RE: Ewing Gravel Pit, DRMS File M2023-033
Adequacy Response 1

The attached letter addresses each adequacy item in your December 11, 2023 letter regarding the Ewing Gravel Pit. Items marked as adequate are omitted. Revised exhibits and maps are attached as well. Feel free to contact my office with any questions.

C-1 Baseline Map

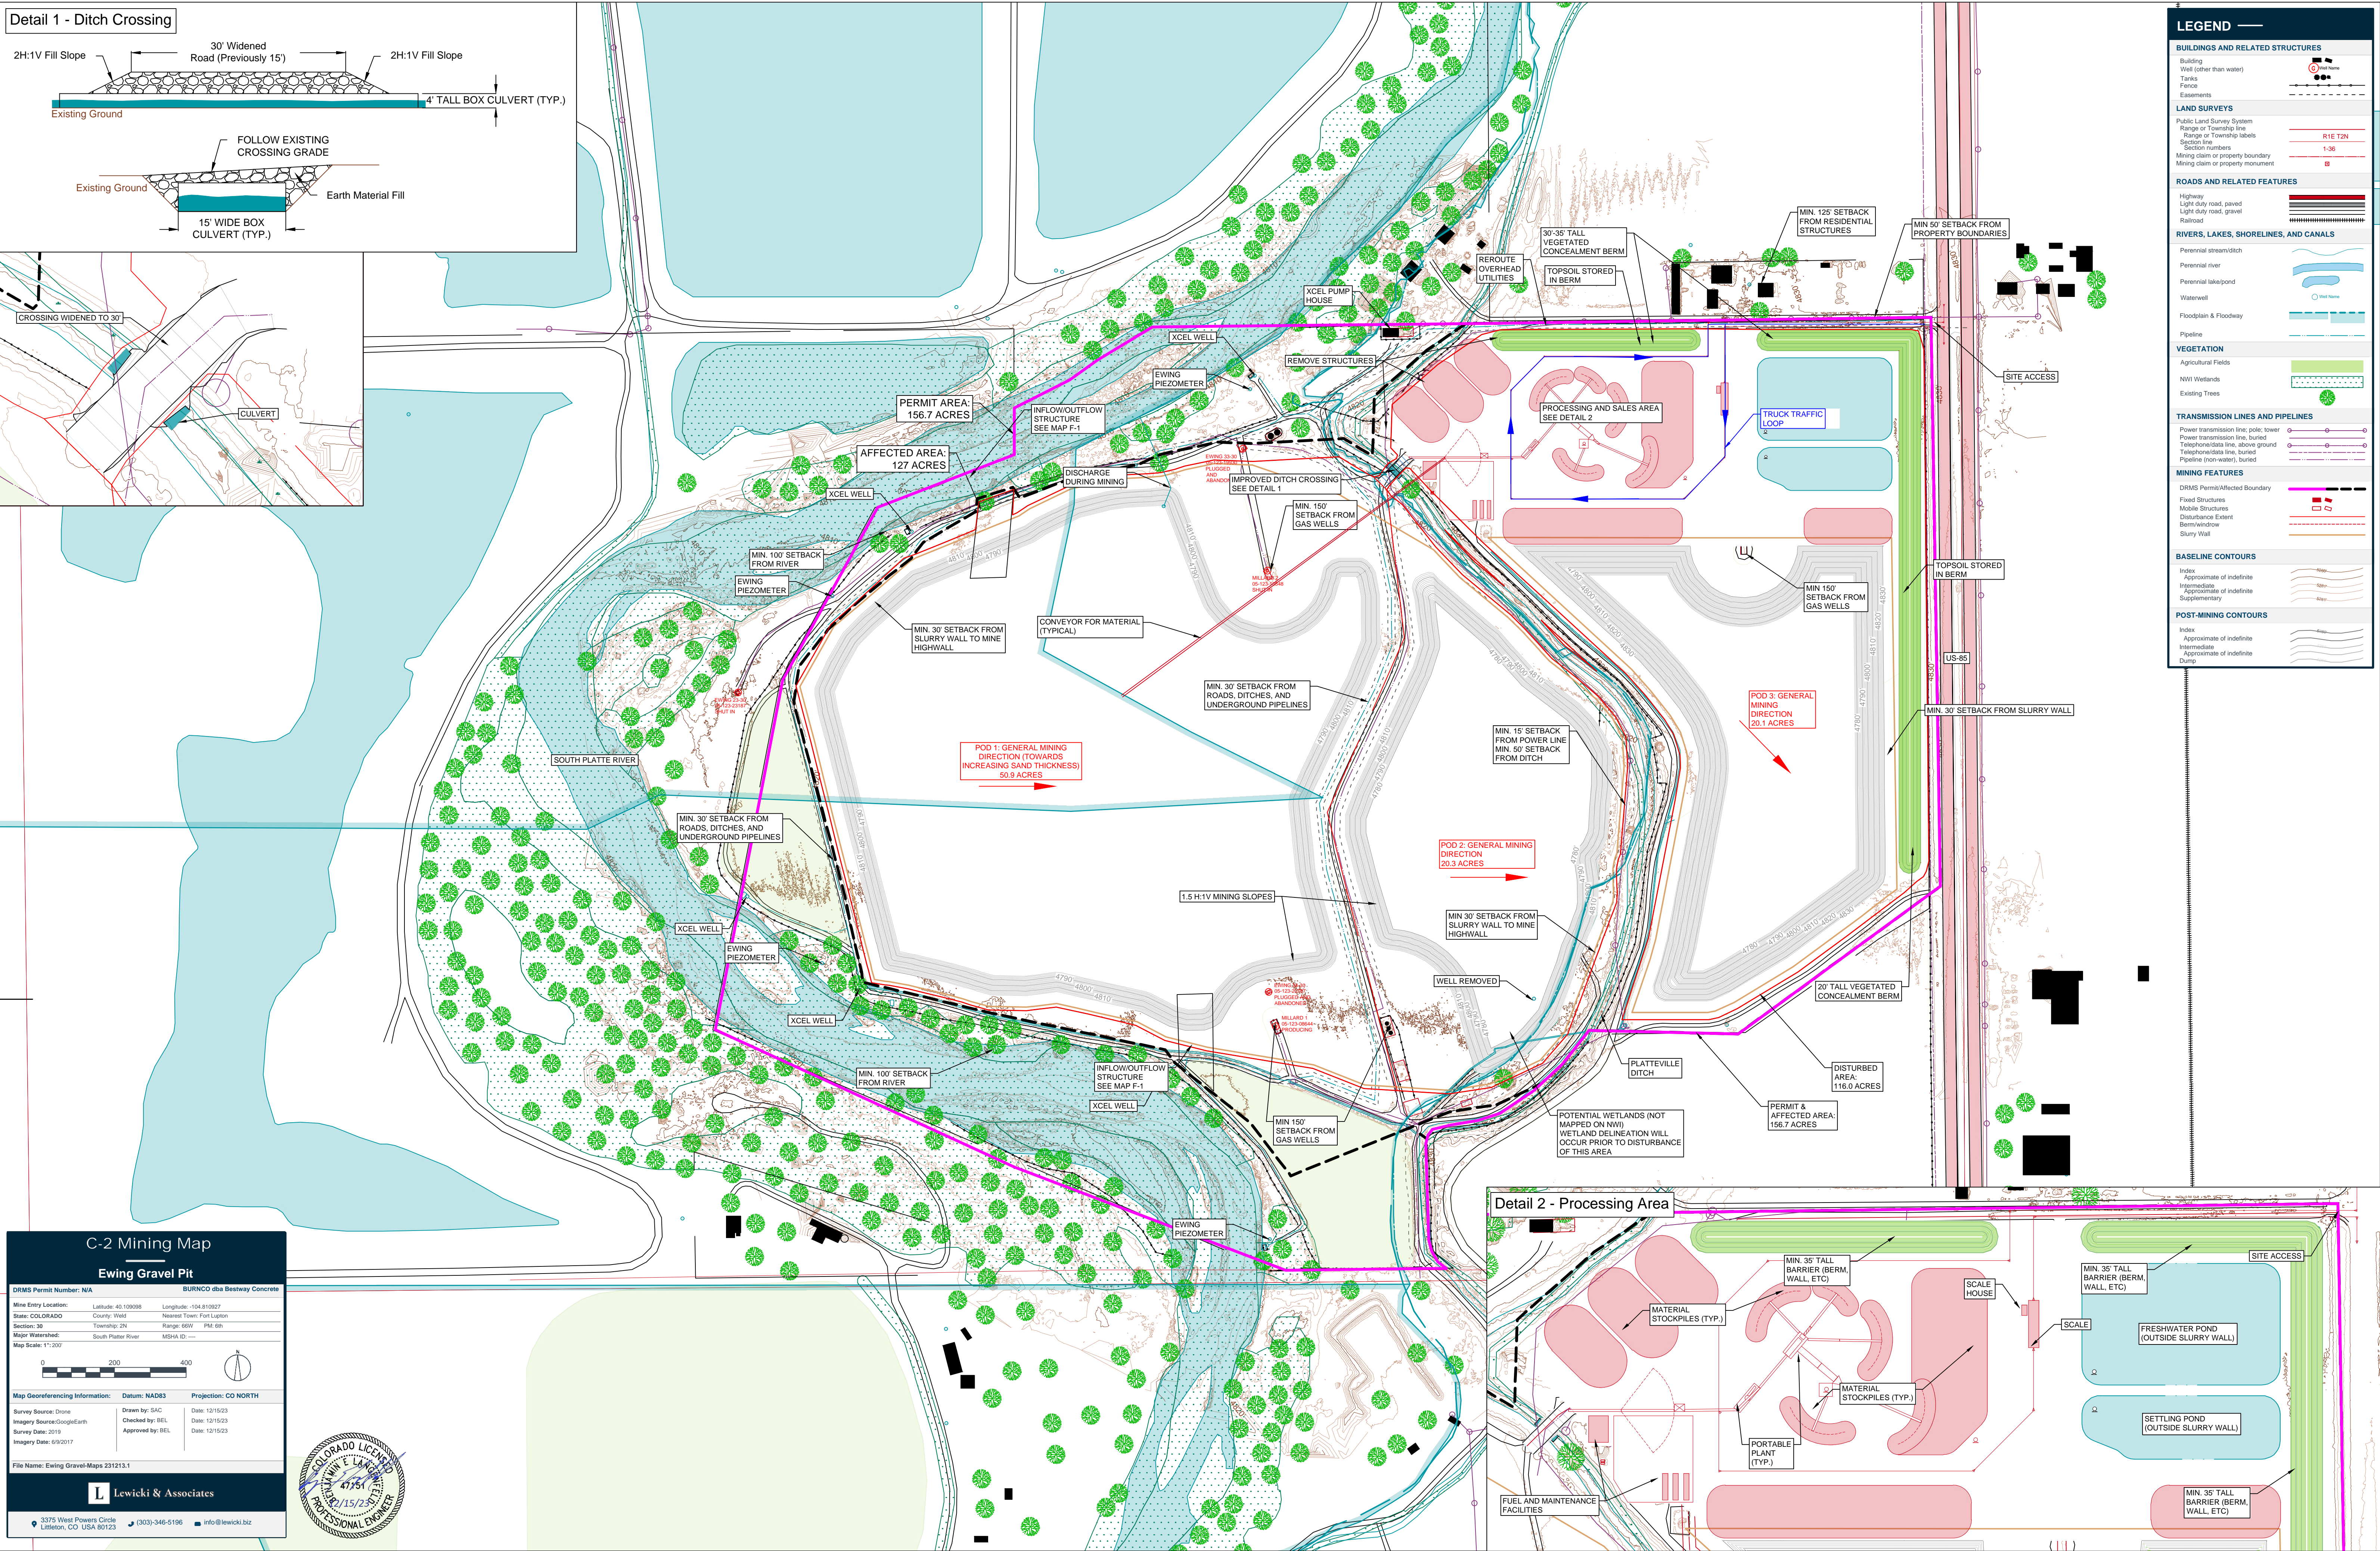
- 1) (d) *The maps provided in the application show a “permit and affected area” of 157 acres, which corresponds to the property parcel boundary, and a “disturbed area” within that of approximately 116 acres.*

The 157 acre “permit boundary/affected area” as shown on the provided maps is not able to be marked as required by rule as it crosses and lies within the South Platte River in several areas. The 116 acre “disturbed area” as shown on the provided maps correlates with the DRMS definition of “affected area” given above, and should therefore be marked as required by rule in the field, and identified as such on all provided maps for this application. Please revise all maps (and all application text) as needed for consistency to clearly identify the 157 acre permit boundary, as well as the 116 acre affected area.

Alternately, if the applicant desires, they may also remove all reference to the 157 acre parcel/permit boundary currently shown in the application, and revise the permit boundary to define the 116 acre affected area in the application and on all maps.

The affected area has been revised on all maps and within the permit text as well as being marked in the field. Please see the revised Exhibits and Maps. Please see the email dated December 7, 2023 from BURNCO showing the location of the affected area boundary markers as well as the mine sign posting.
